ADDENDUM NO. 2

DATE: March 27, 2024
TO: All Offerors
FROM: Bryan Holloway, Senior Buyer
TOTAL PAGE(S): 1 pages (not including attachments)
SOLICITATION TITLE: Military Building Tailor Shop Renovation
SOLICITATION NUMBER: IFB # 218672410

Construction Administration
Submittal Review Comments

Item Submitted: RTU - 1

WIRING DETAIL 1 (OUTDOOR)

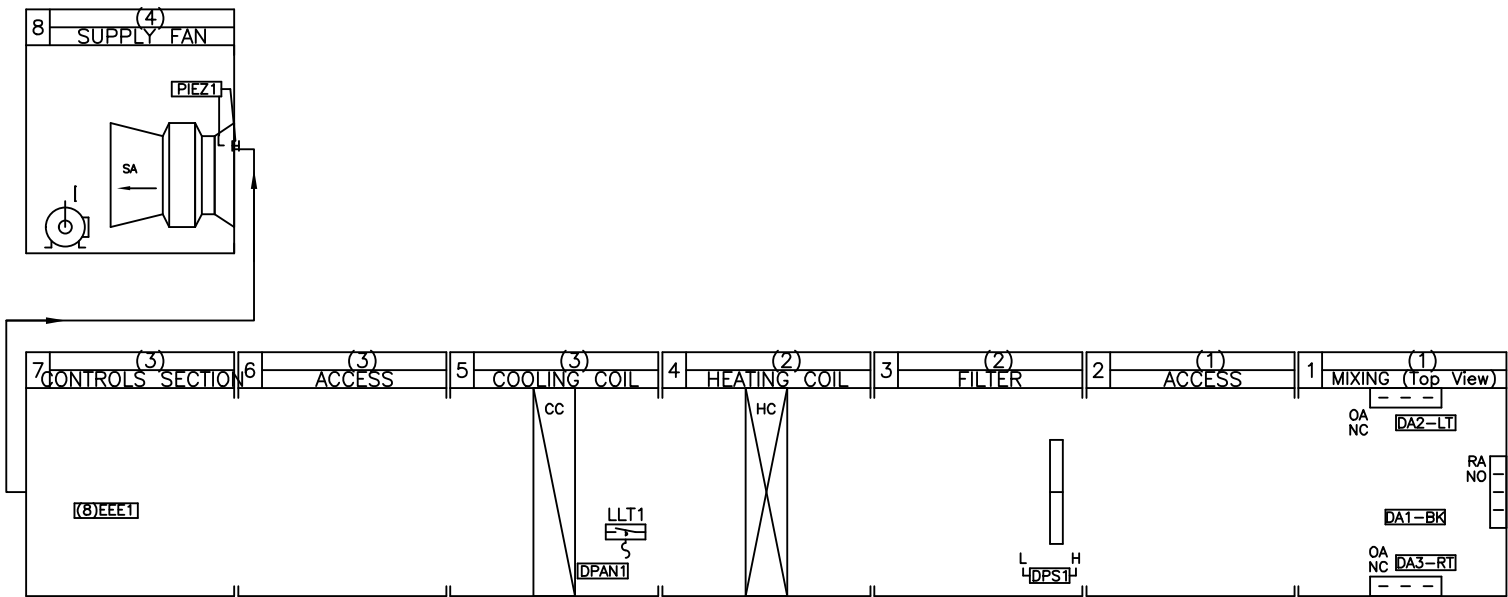
Electrical drawings show single point connection to RTU-1. Verify fan and associated VFD is powered by the unit and does not need a separate power connection.
